Service Bulletin

Bulletin No.: 18-NA-078

Subject: 2nd Row Center Seat Belt Not Retracting Fully or Unable to Extract

Brand:	Model:	Model Year:		Build Date Breakpoint:		Engine:	Transmission:
		from	to	from	to		
Chevrolet	Traverse	2018	2018	June 1, 2017	October 31, 2017	All	All

4960953

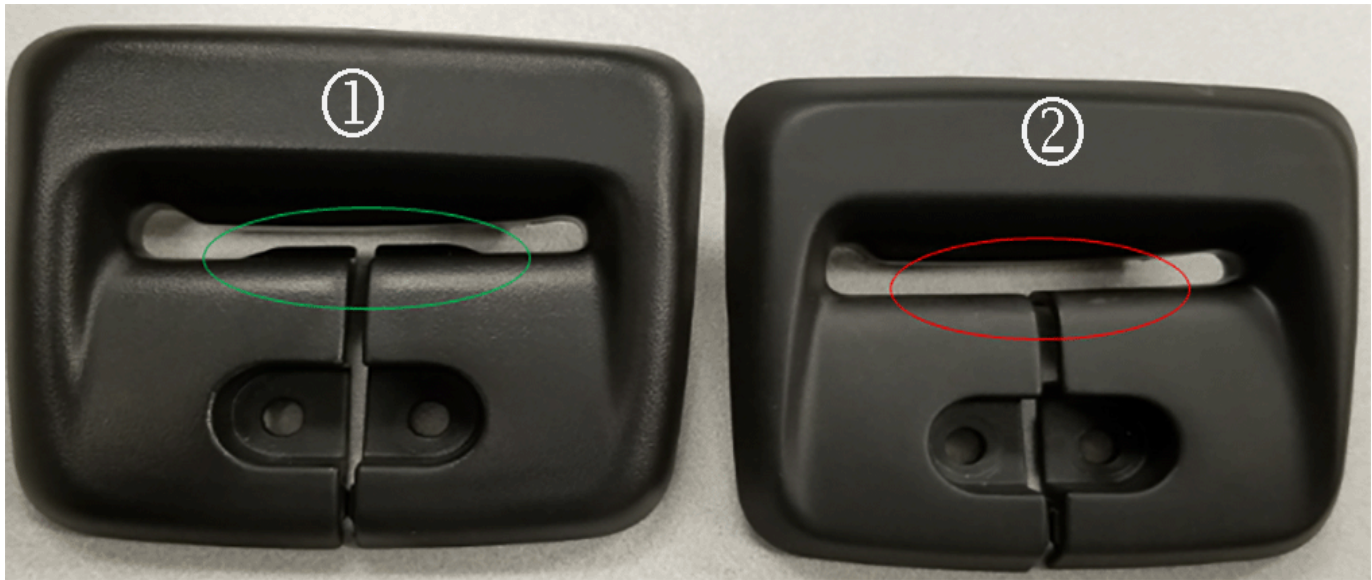
5. Replace the original seat belt opening bezel (2) with the appropriate color new design service part (1), listed in the Part table below.
6. After installation, ensure the seat belt is extracting and retracting normally.

Important: Ensure the bezel is properly and fully seated.
